U. S. ATOMIC ENERGY COMMISSION  
REGION V  
DIVISION OF COMPLIANCE

Vendor Inspection Report  
Primary System Pumps

Report Number: ESCO 69-2

Indian Point No. 1 and 2. Inspection  
made with reference to ASME Code  
Sections I, III and VIII, Divisions 1  
and 2, Special Ruling Case 1355-2, and  
ASME, Sections III and IX in general.

ELECTRO-SLAG WELD  
FACILITY. GEN. ARMS/INT

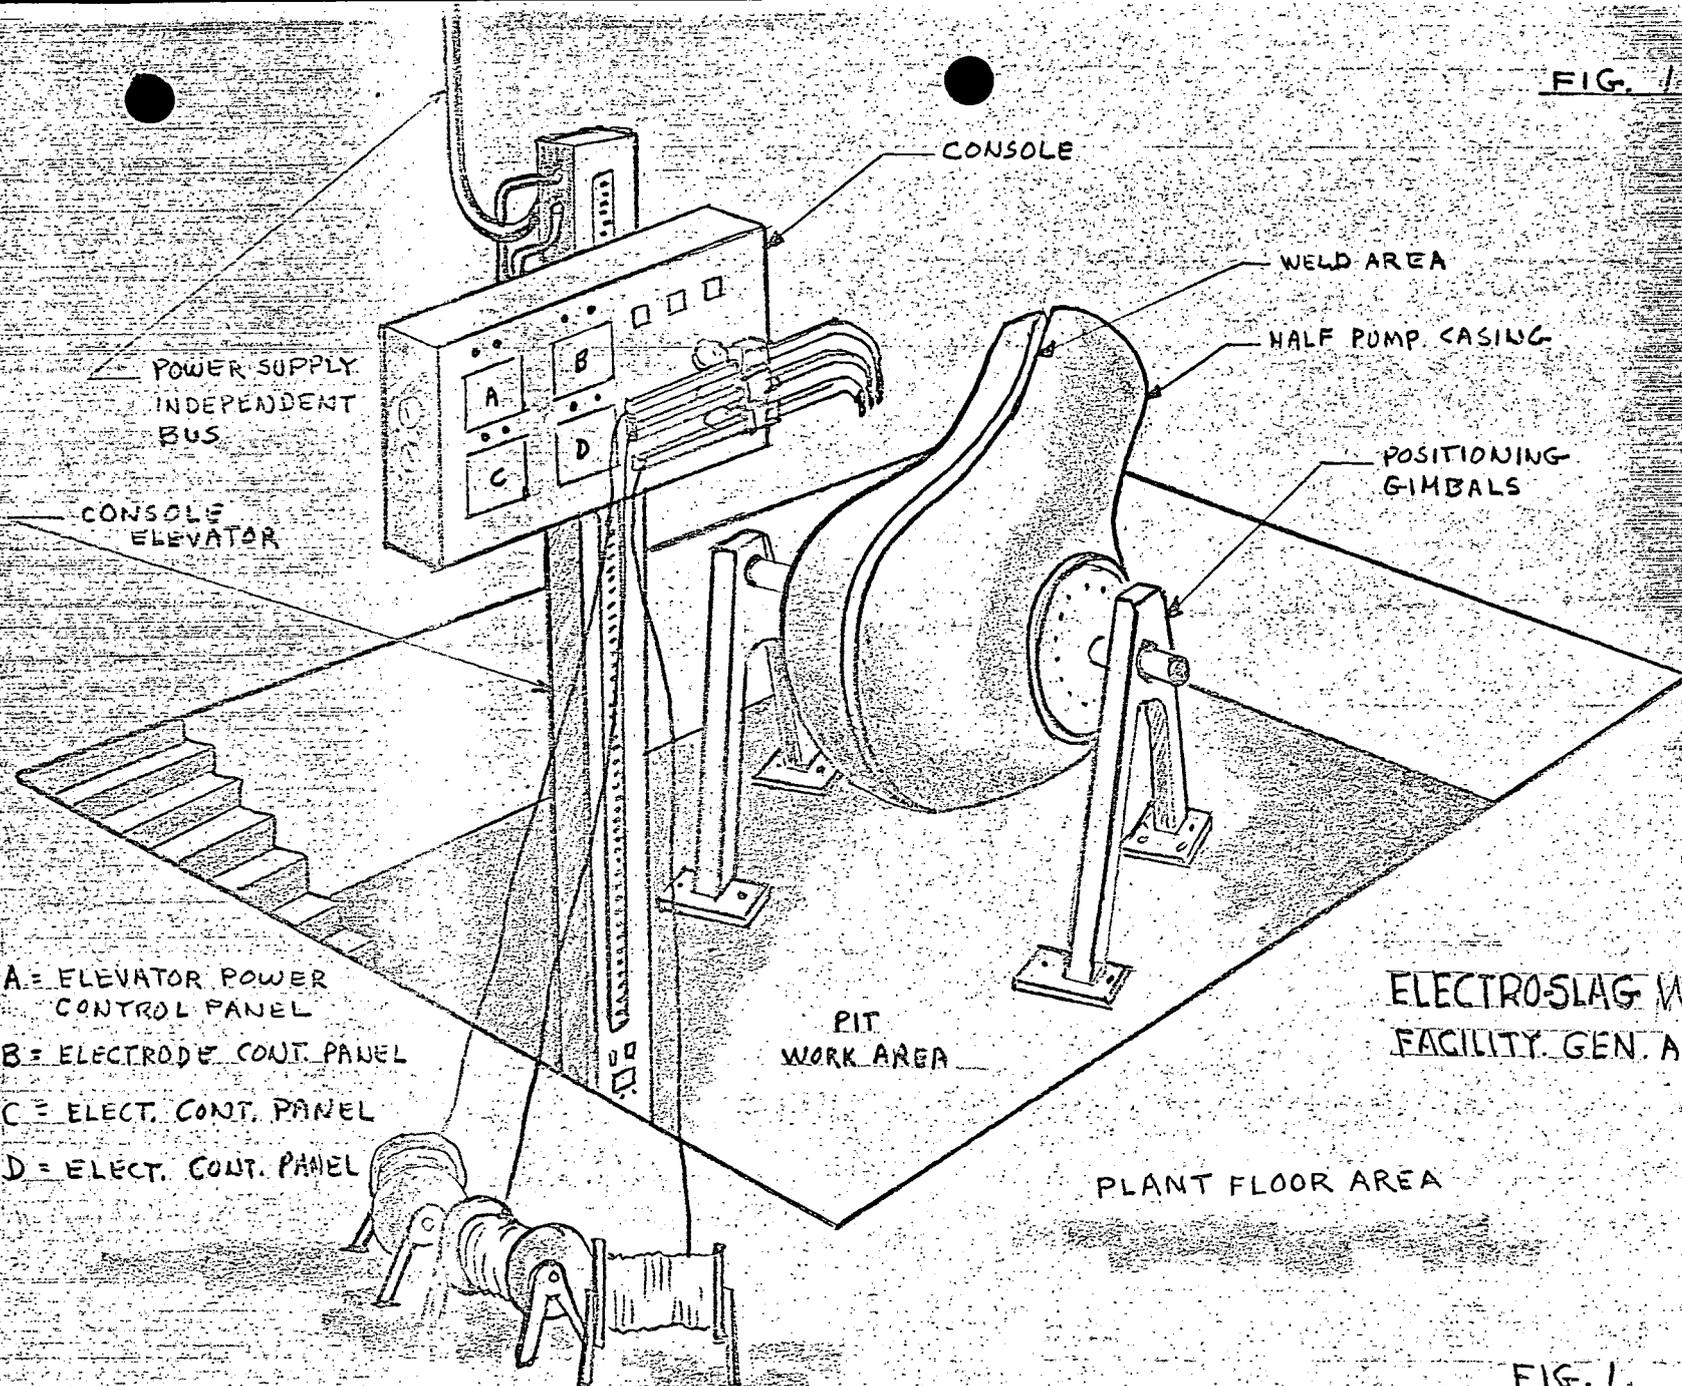
- b. During the E-S welding operation, the procedures require that any problems or anomalies encountered are to be noted on the traveler form and flagged for NDT attention. An example of use of this requirement, according to Mr. Hunt, would be an unusual appearance of the "heat spot" (see Figure 1, attached) which follows the weld as the weld pool rises. Hunt explained that E-S welders have learned to relate an abnormal heat spot appearance to a potentially bad weld and, therefore, mark any such areas noted during the weld operation for special NDT attention.
- c. The E-S welding records were reviewed and considered to be somewhat inadequate in that no records of critical procedure parameter values, such as voltage, current, wire speed and wire travel frequency and dwell, are maintained except in the case of test block welds.

2. Welding Equipment (See Figures 1, 2 and 3, attached)

One basic electroslag welding unit is used in all production welding. This unit is an ARCOS welding machine, adaptable to one, two or three wire feed and was originally imported from Belgium. The unit has been extensively modified by ESCO, mainly to improve the wire feeding and oscillation mechanisms. A Miller constant voltage AC power supply provides the welding current. The contact tubes are made from copper-tungsten material (supplied by Mallory Corporation) and possess excellent electrical properties. No feeding or electrical contact problems are encountered except that heat erosion of the contact tube is an economic consideration. Also, wire distortion resulting from positive feed mechanisms (crimping) has been an undesirable situation due to electrode tip wear caused by the crimped surface of the wire acting as a file.

# TEST BLOCK AND ELECTRODE DETAIL

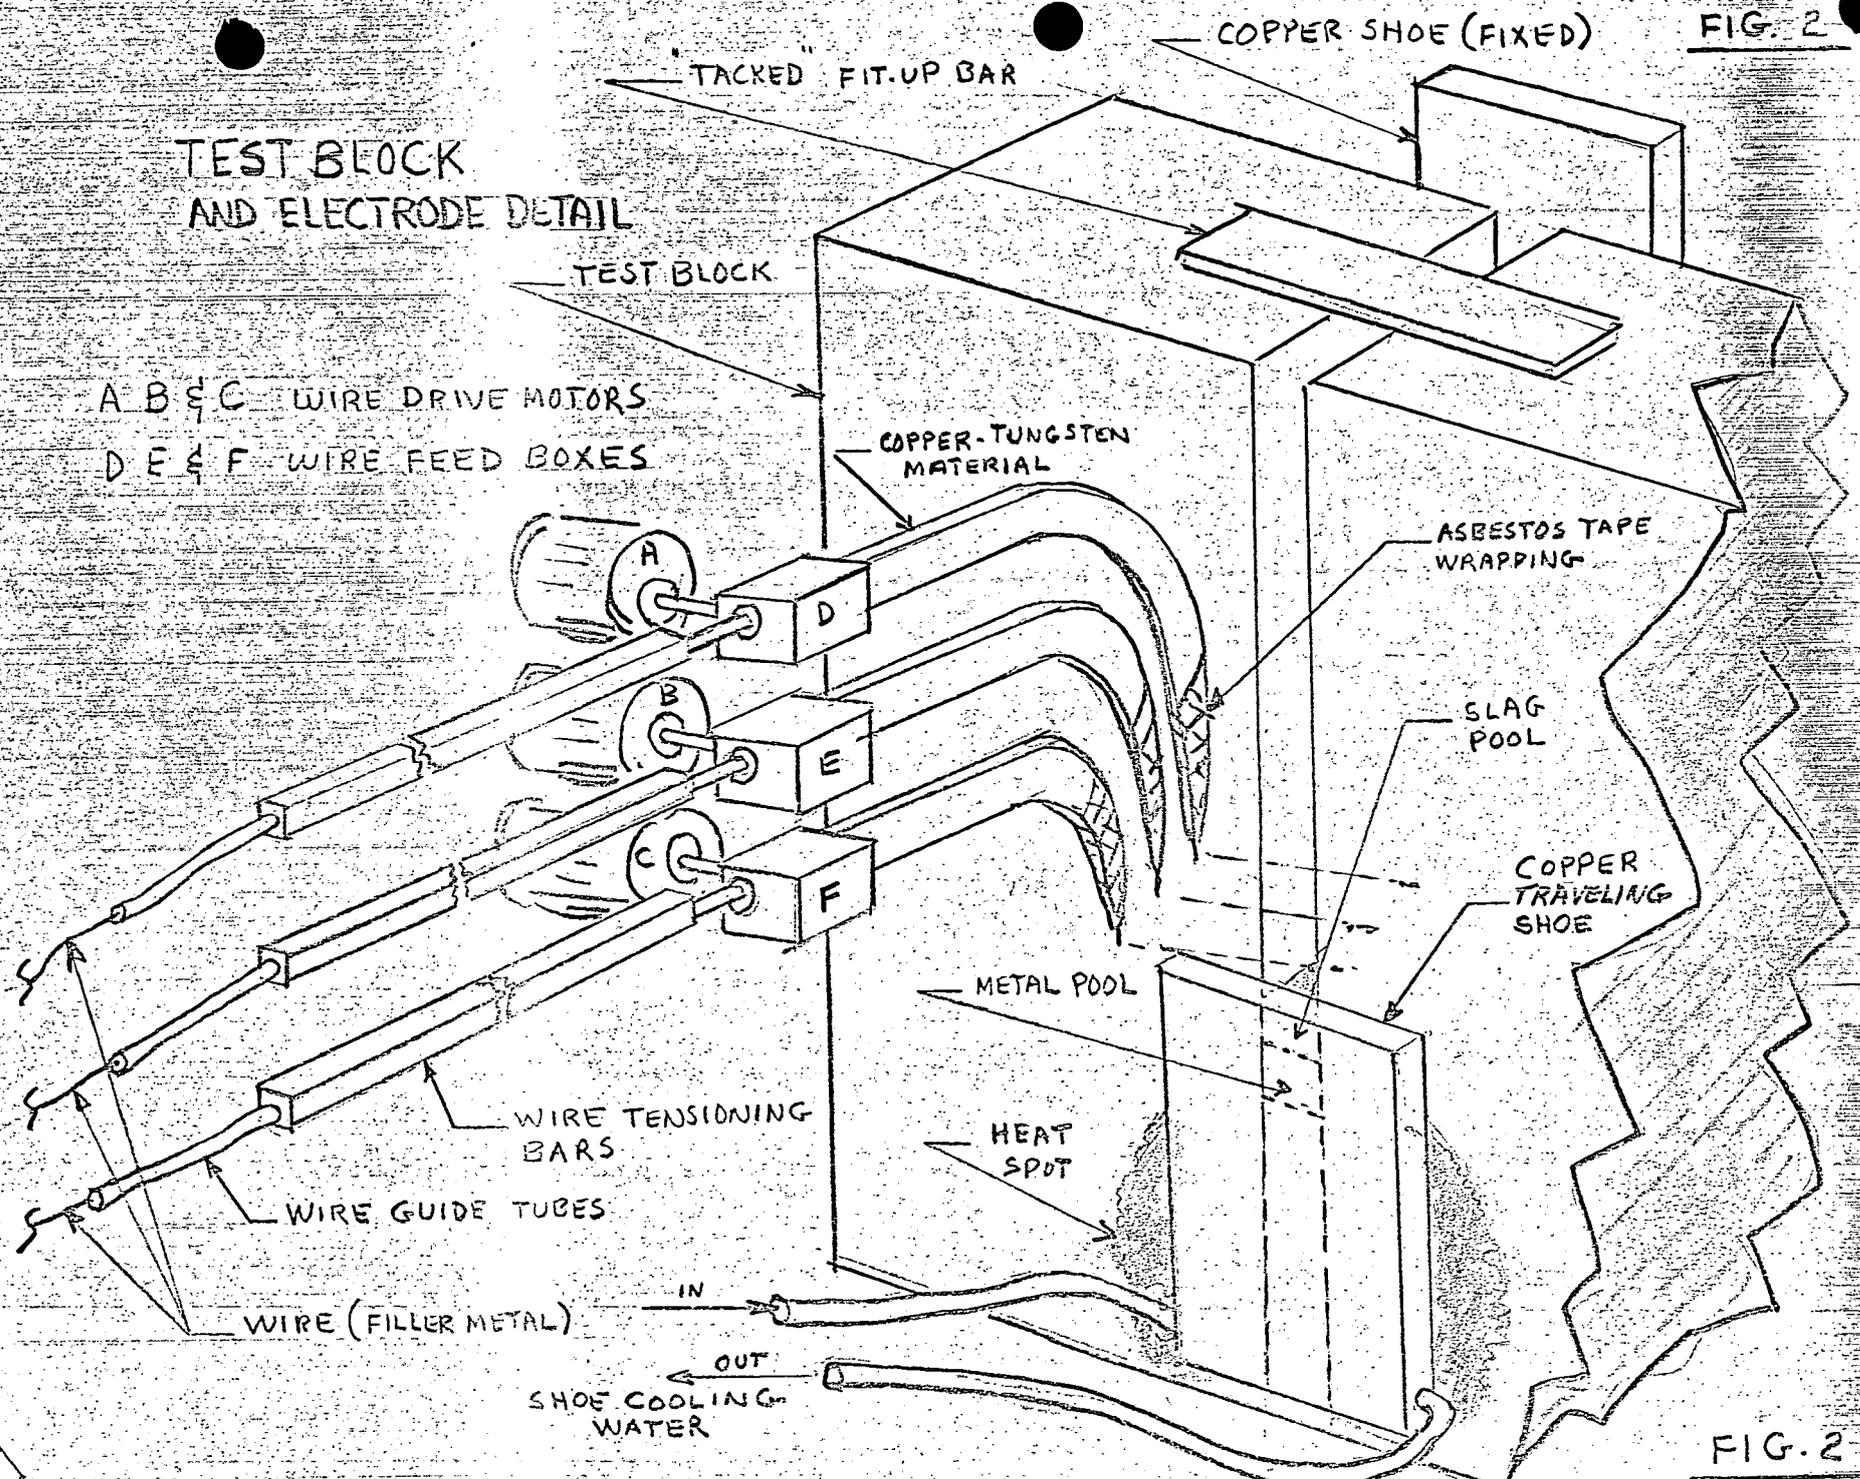
During the visit on June 10, 1969, ESCO personnel performed a routine E-S test block weld for qualification purposes (see Figures 2 and 3, attached). The test block was SA 351 stainless steel and was approximately eight inches thick. The weld was being performed in accordance with ASME Qualification Procedure No. 21 (two wire) and two qualified E-S welders were in attendance at the time of the inspector's observations. According to Mr. Groshart, all E-S welding is performed with a minimum of two qualified E-S welders in attendance. He added that, for very complex E-S welding operations, as many as four qualified E-S welders are utilized. Figures 1, 2 and 3, attached, are sketches of the ESCO E-S welding equipment and reflect observations made by the inspector during the test block E-S welding operation on June 10, 1969. As shown on the sketches, the E-S equipment includes an independent power supply (transformer-to-bus).

The majority of nuclear castings produced by ESCO conform to ASTM-A351 grades CF8 or CF8M (casting equivalent of types 304 and 316). In practice, ESCO alloy designations are used. Welding wire is purchased to ASTM A371, ER308 (or ER308L), and ER316 to match the two casting compositions. Several filler metal suppliers are utilized. ES welding of a test plate was observed during the inspection (see Figure 2, attached).

ESCO welding procedure specifies a voltage range of 38-56 volts. In practice, the voltage is maintained within much closer range (48-50 volts is typical). The welding of a customer's test plate was observed during the inspection. Momentary voltage fluctuations ranging from 40 to about 60 volts were observed, but the process had just been started and had not stabilized.

FIG. 3

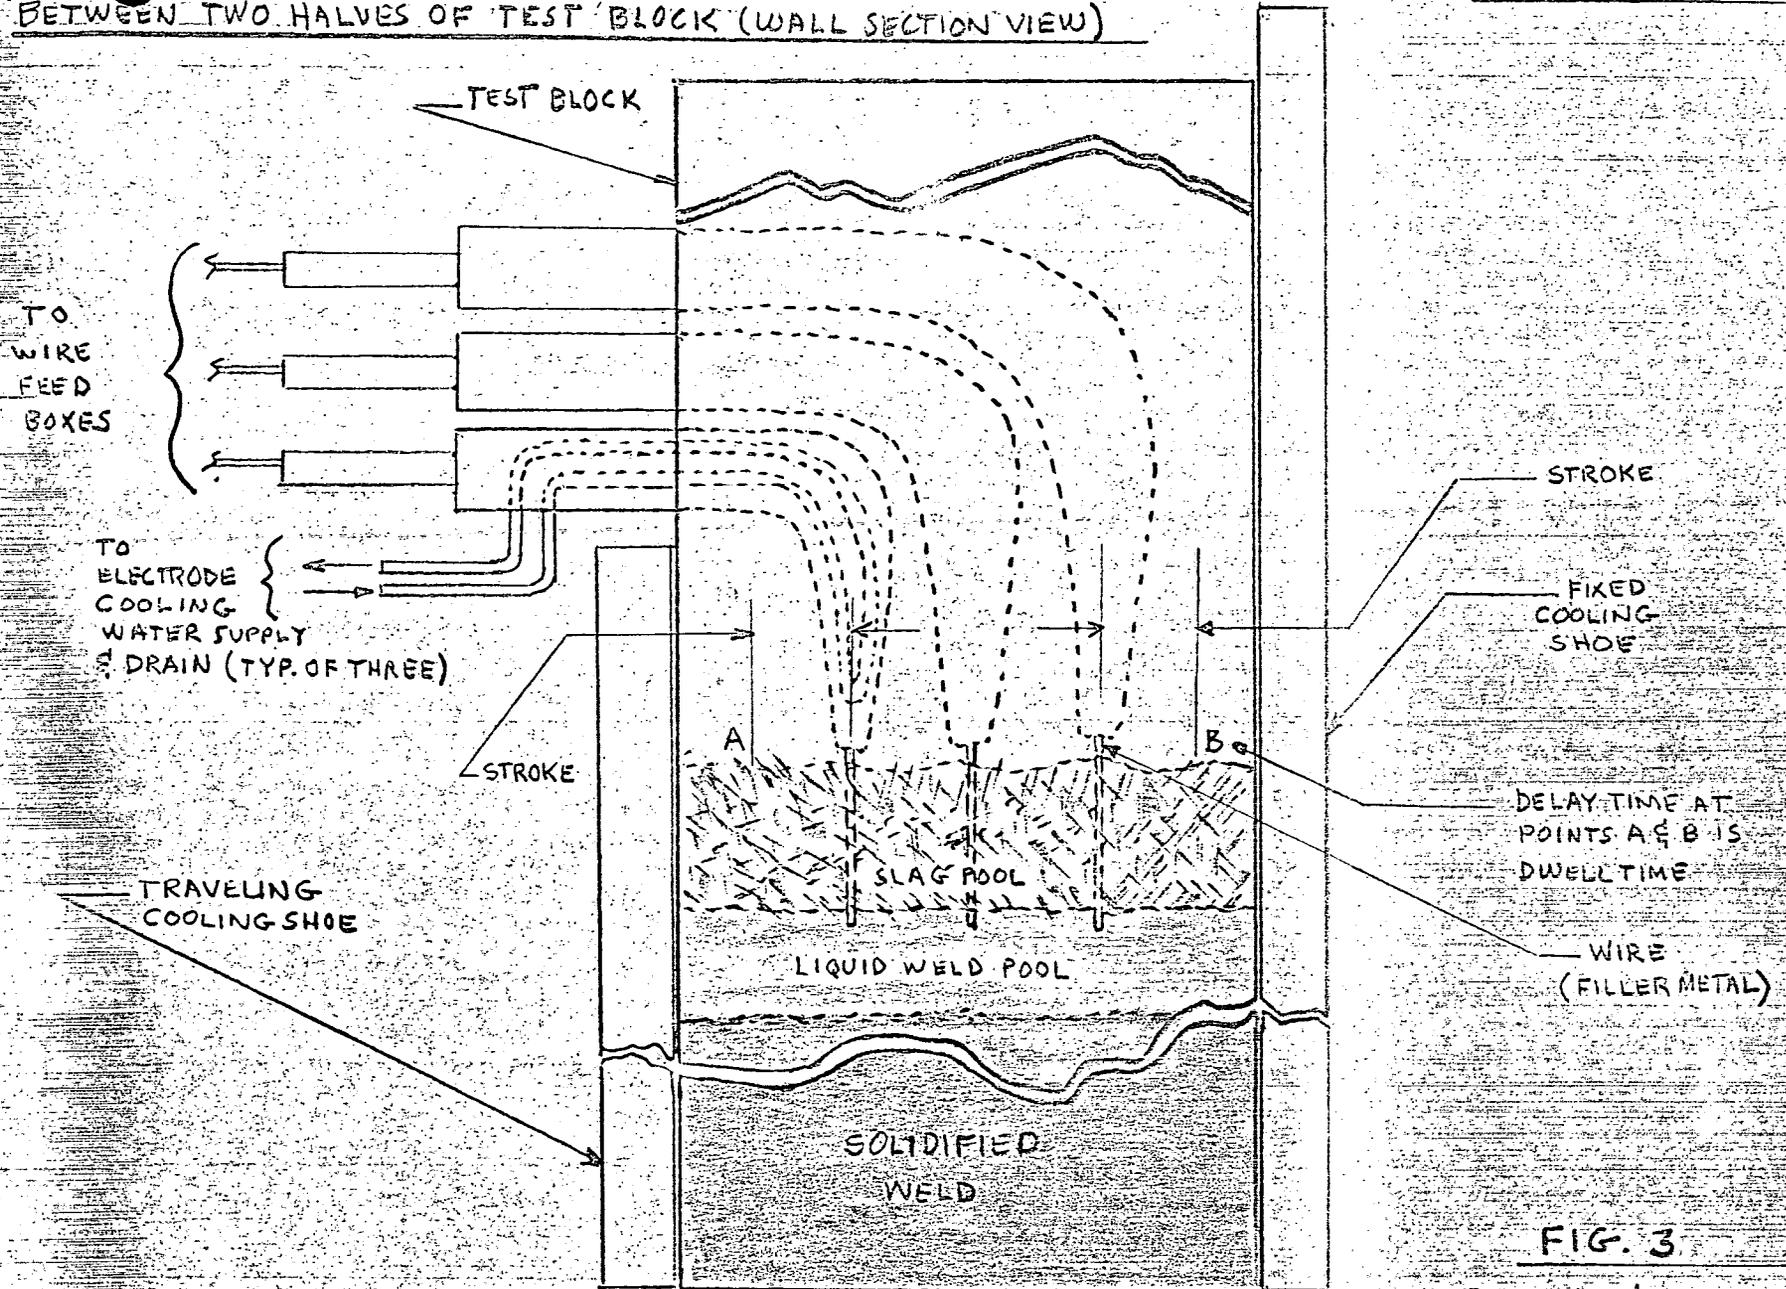
These parameters are adjusted according to the material thickness and are recorded on the welding data sheet. No specific limits are prescribed in the welding procedure but common practice is to provide for travel such that the inside and outside electrode tips approach to within 1/2 inch of the back (fixed) shoe and to within 3/4 inch of the front (traveling) shoe.

The slag depth is maintained at 3/4 to 1 inch, although no specific limits are set by the welding procedure. Dip-stick method is used to check the slag depth during production welding. Flux is replenished manually, using a pouring cup.
